PLAN CHANGE 75  
TE PUKE FLOODABLE  
AREAS AND AREA 3  
STRUCTURE PLAN REVIEW  
PLANNING REPORT

*Western Bay of Plenty  
District Council*

March 2017

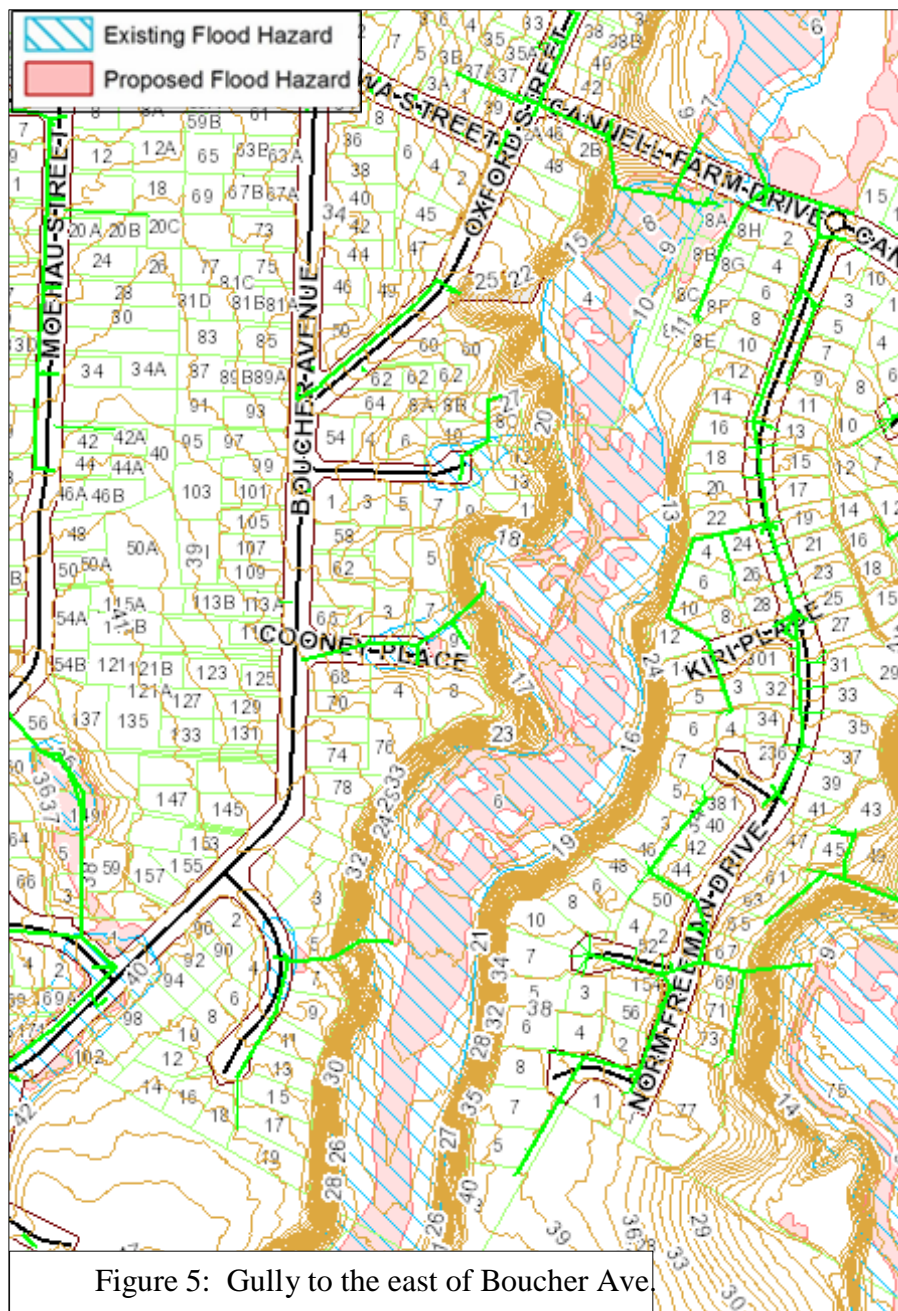
The proposed notation included in figure 4 is opposed by Submitter 6.

As per Submission Point 6.2, Submitter 6 is of the opinion that the proposed notation is incorrect. According to Submitter 6, the overland flow is along the northern boundary of 9 Cooney Place (between 7 and 9 Cooney Place). According to Submitter 7 Cooney Place is slightly higher than 9 Cooney Place and should not be included in the notation. The notation should cover the overland flow path, which is along the stormwater pipe on 9 Cooney Place to the edge of the bank. The proposed notation is along the driveway of 9 Cooney Place.

Council engineers visited the site and reviewed the model. It was clear from the site walkover that there is an overland flow path running through 9 Cooney Place. The property at 7 Cooney Place is higher than 9 Cooney place confining the flow path to 9 Cooney Place only. This information is then further supported by the stormwater model. The model indicates the overland flow path will reach a depth of 60-90mm along the northern boundary. As Council only notates ponding or overland flow paths greater than 100mm the strip along the northern boundary has not been included in the proposed notation. However, there is a slight depression in front of the dwelling at 9 Cooney Place where the water will pond greater than 100mm, which has been captured by the proposed notation. The aerial photo below is an extract from the model. The blue squares represent the area where flood water will exceed 100mm, which corresponds with the proposed notation.

1. The proposed notation be retained as notified.

- a) Council engineers visited the site and reviewed the model. It was clear from the site walkover that there is an overland flow path running through 9 Cooney Place. The property at 7 Cooney Place is higher than 9 Cooney place confining the flow path to 9 Cooney Place only. This information is then further supported by the stormwater model. The model indicates the overland flow path will reach a depth of 60-90mm along the northern boundary. As Council only notates ponding or overland flow paths greater than 100mm the strip along the northern boundary has not been included in the proposed notation. However, there is a slight depression in front of the dwelling at 9 Cooney Place where the water will pond greater than 100mm, which has been captured by the proposed notation. The aerial photo below is an extract from the model. The blue squares represent the area where flood water will exceed 100mm, which corresponds with the proposed notation.

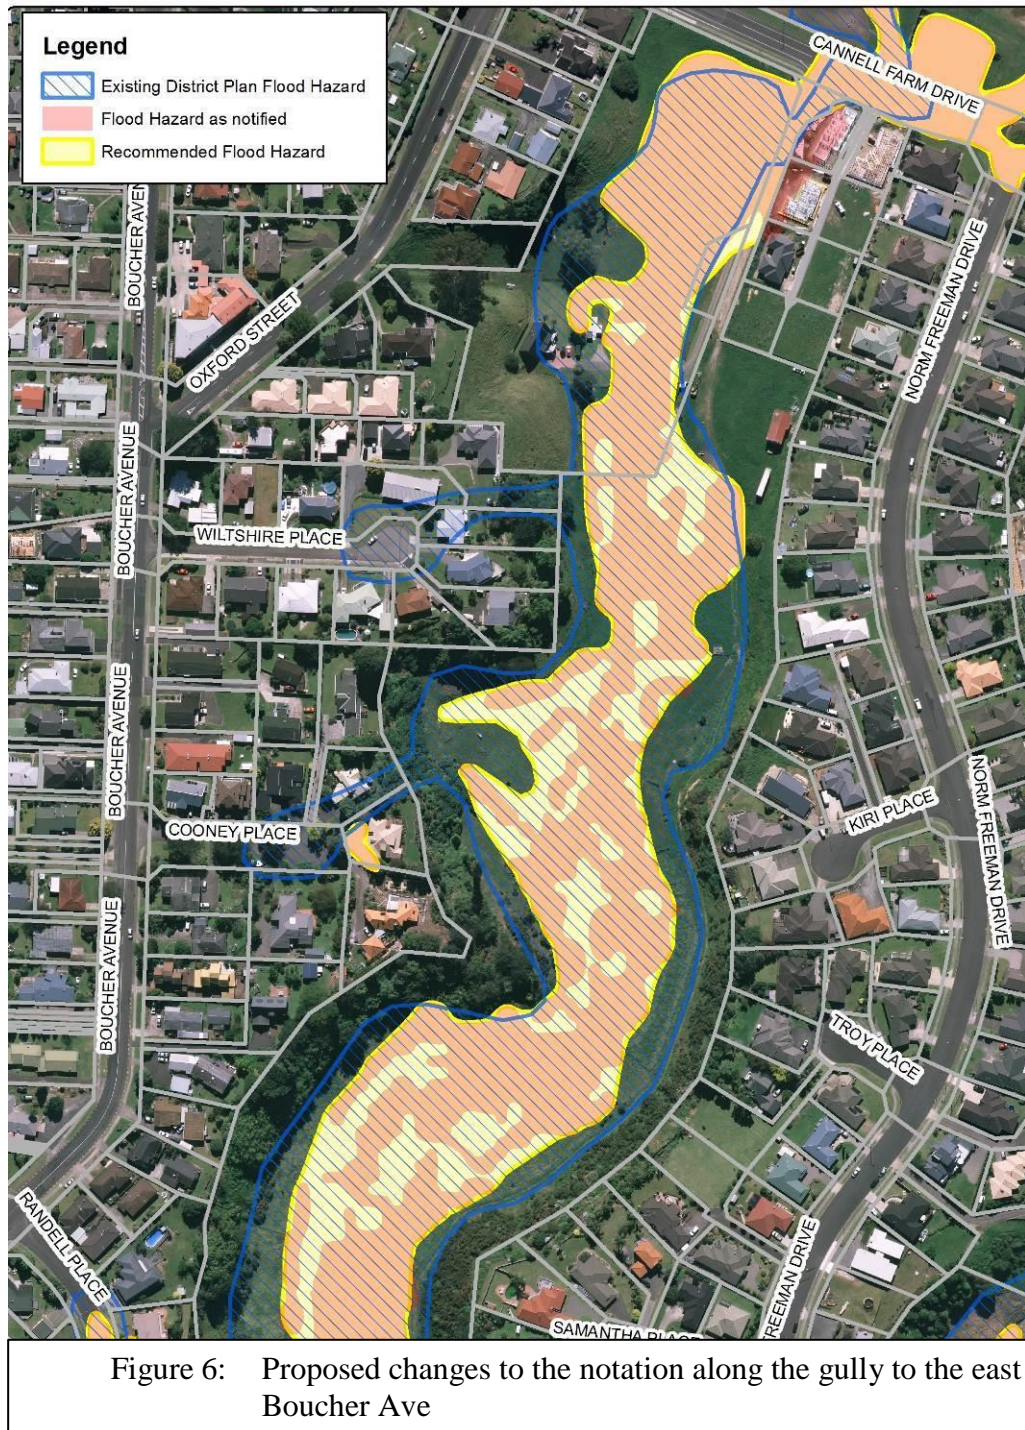
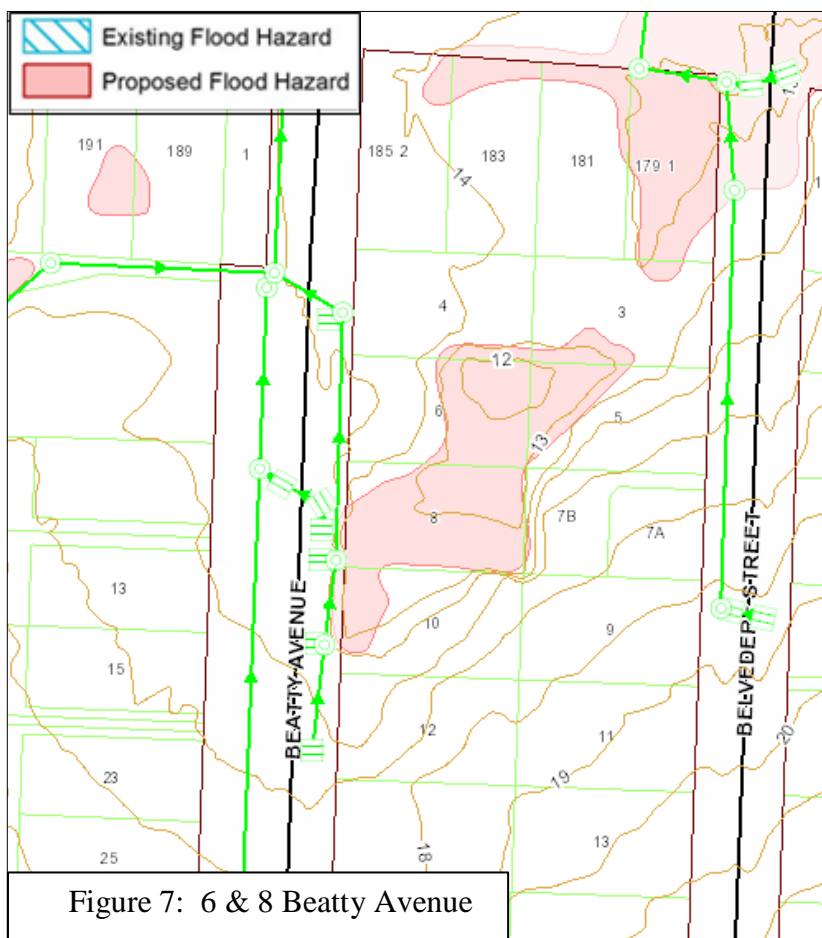
Submitter 6 provided photos to support the argument that the operative notation along the gully south of Cannell Farm Drive should be retained and therefore opposed the proposed 'reduced' notation.

Council staff reviewed the model and proposed notation and agree with the comments of Submitter 6. There appears to be local 'highspots' within the gully at which point the water will flow over/around during a flood situation. However, it is impractical to exclude these from the flood hazard notation. The amended notation is included in 2.6.2 Recommendation.

1. The proposed notation be amended as per Figure 6 below.

Council staff reviewed the model and proposed notation and agree with the comments of Submitter 6. There appears to be local 'highspots' within the gully at which point the water will flow over/around during a flood situation. However, it is impractical to exclude these from the flood hazard notation.

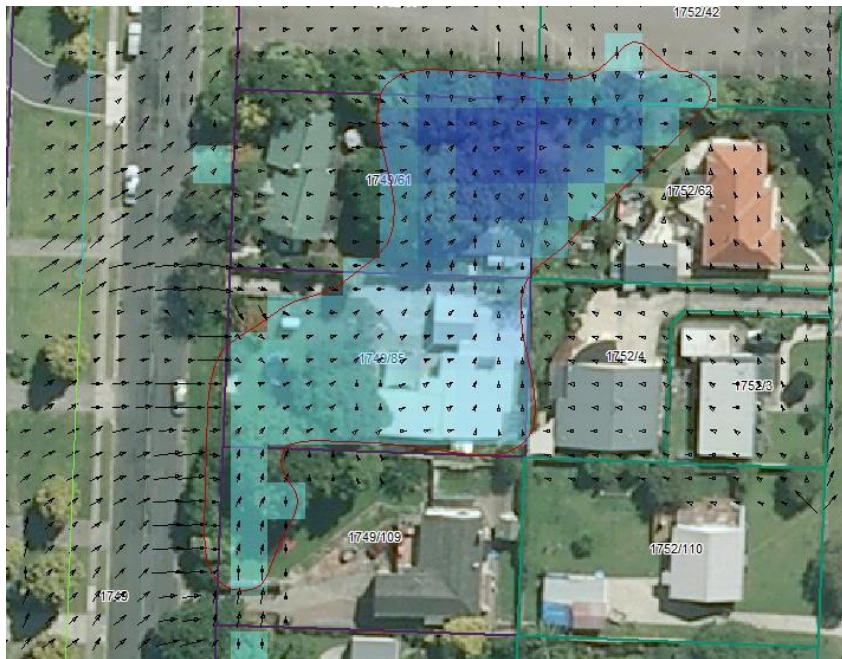
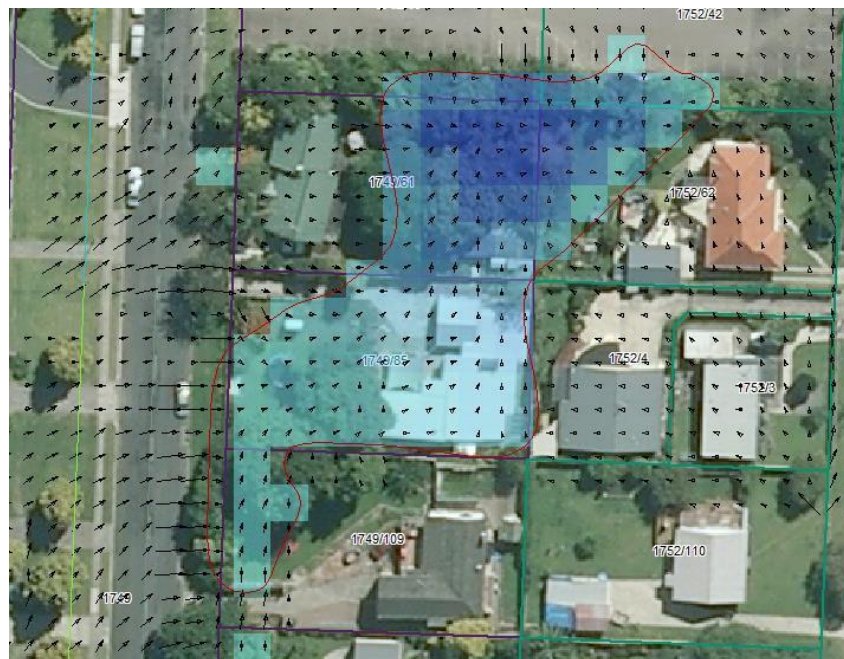
The proposed notation shown in Figure 7 is opposed by Submitters 13 and Further Submission 31.

It will be noted from the contours included in Figure 7 that 6 and 8 Beatty Avenue are in a 'localised' depression.

Submitter 13 and Further Submitter 31 believe that flooding can be avoided if Council cleans the catch pits on a regular basis. As a result they advocate that the proposed notation be removed from their properties and Council increase the level of catch pit cleaning service along Beatty Avenue.

The screenshot below shows an extract from the model. The areas highlighted in blue illustrate flooding deeper than 100mm (the darker the blue means the deeper the flooding).

The extent of the flooding might be alleviated by undertaking certain actions, e.g. cleaning the catchpits more regularly, changing the profile on the vehicle crossing at 8 Beatty Ave or installing an additional stormwater pipe from the northern boundary of 6 Beatty Ave to Council infrastructure in either Beatty Ave or Belvedere Street. Council's Utilities Team will include these investigations in their work programme. However, these investigations will be done outside of this project.

1. The proposed notation be retained as notified.

- a) Most of 8 Beatty Ave and the back portion of 6 Beatty Ave are in a 'localised' depression which gets flooded during a significant storm.
- b) The proposed notation is based on a one in fifty year storm event and as a result the existing stormwater infrastructure will not be able to manage the stormwater from such an event.

- d) The extent of the flooding might be alleviated by undertaking certain actions, e.g. cleaning the catchpits more regularly or changing the profile on the vehicle crossing at 8 Beatty Ave. Council's Utilities team will include these investigations in their work programme. However, these investigations will be done outside of this project. The notation needs to be retained until the work has been completed and the extent of flooding reviewed.

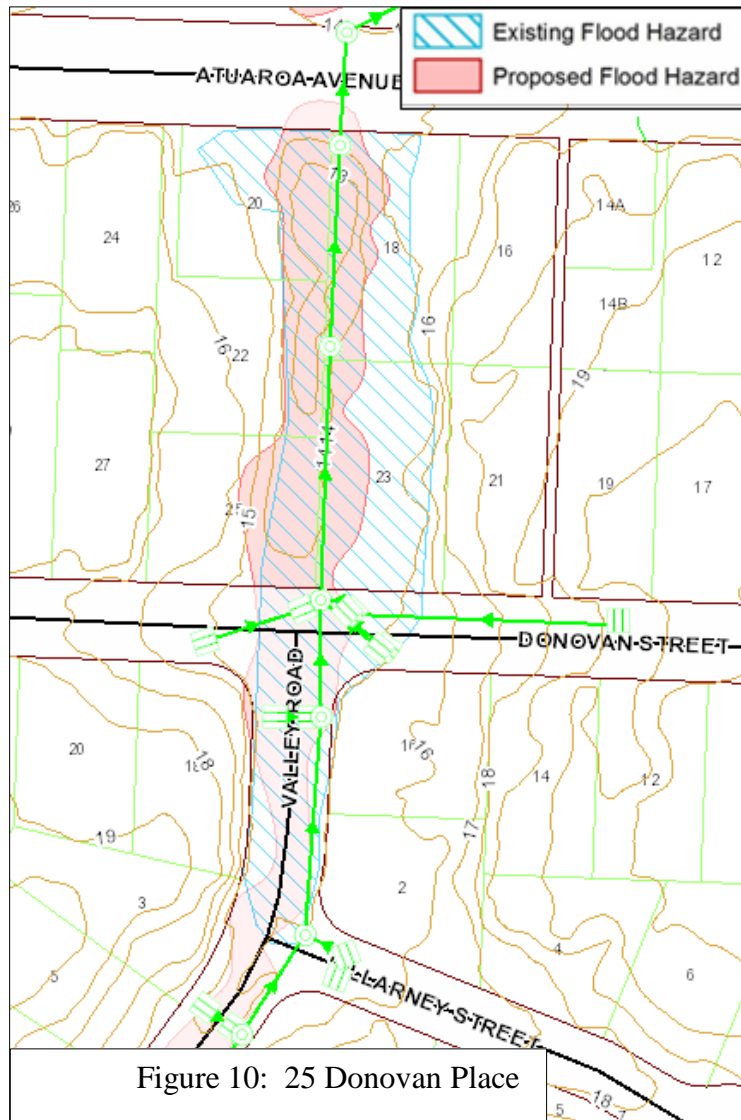
Submitter 1 is of the opinion that the stormwater enters 25 Donovan Street due to stormwater infrastructure that is undersized and needs to be upgraded.

Valley Road is an overland flow path with a 450 diameter stormwater pipe. There are a number of catch pits within the Valley Road / Donovan Place intersection that collect stormwater from both roads. The diameter of the stormwater pipe is thereafter increased to 750 and this pipe runs through 23 Donovan Place and 18 Atuaroa Avenue and opens up into an open drain through Centennial Park. This is a significant overland flow path and needs to be retained and managed through the District Plan.

Staff met with the landowner in February 2017 and he agreed that part of his property will flood and that the proposed notation is correct. However, he mentioned that the risk of flooding can be reduced if small improvements are

1. The proposed notation be retained as notified

- a) The notation is based on a one in fifty year storm event. The lower lying area between Donovan Street and Atuaroa Avenue, which includes 25 Donovan Street as an important overland flow path needed to manage stormwater during a storm event greater than a one in five year event.
